Wollongong Local Planning Panel Assessment Report | 17 October 2018

WLPP No.	Item 3
DA No.	DA-2017/1666
Proposal	Subdivision - Torrens title - seven (7) lots
Property	Lot 2 DP 1190049, 10 Hillside Crescent, Stanwell Park NSW 2508
Applicant	Mr Jed Gilmour, Mr Lee Mathew Gilmour, Mr Simon David Leslie and Mr Theodorus Willhemus Van Der Pavert, C/- Develop My Land
Responsible Team	Development Assessment and Certification - City Wide Planning Team (AK)

ASSESSMENT REPORT AND RECOMMENDATION

Figure 3: 88b Restriction No. 2 (Restricted Building Zone - dripline of existing trees)

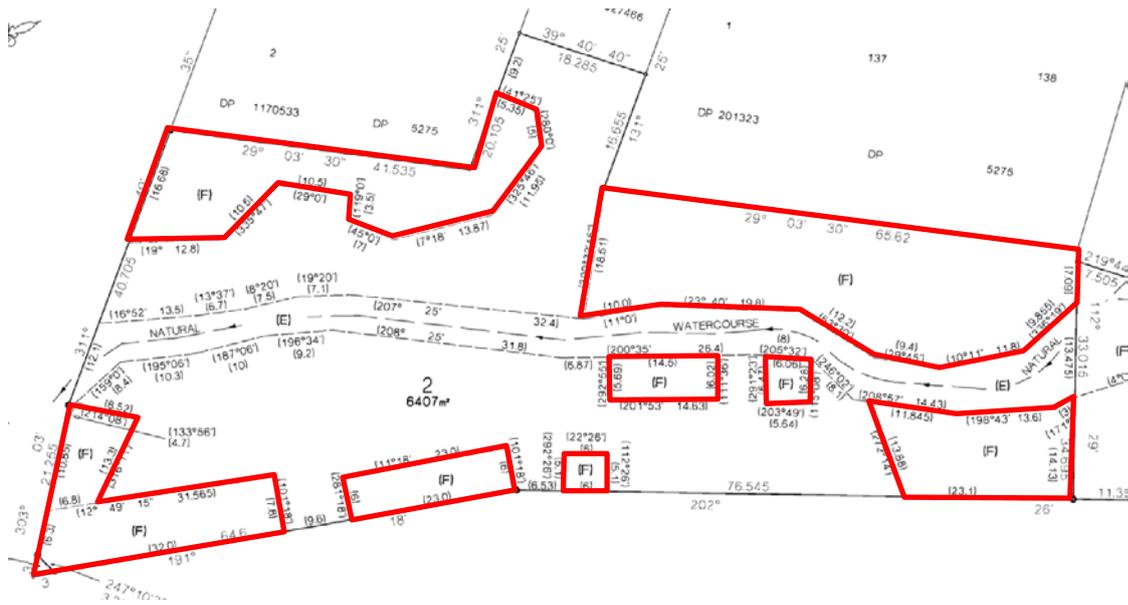
However, the proposed works within the area identified as restriction numbered 2 (F) is not considered acceptable (See Figure 3). Restriction numbered 2 (F) was established as restricted building zones onsite for the retention of trees and vegetation as part of DA-2002/2186 for a 2 lot subdivision as outlined at Figure 4 below (RBZs marked in red). The 88b restriction from DP 1190049 below at figure 3 reads as follows:

The current application proposes a variety of works within these restricted building zones including building envelopes (one is non-compliant), driveways and turning heads, stormwater drainage lines, sub-surface drainage lines for geotechnical purposes, and tree removal. The application proposes the release and modification of these restricted building zones; however, this is in conjunction with a significant level of works as outlined above to facilitate the subdivision. As noted throughout this report the extent of works proposed within these established restricted building zones is considered inappropriate given the constraints of the site and the trees located within these areas. This is identified below in figure 5 extracted from the conditions of consent for DA-2002/2186, condition 29 iv, which established the restricted building zones for all trees onsite.
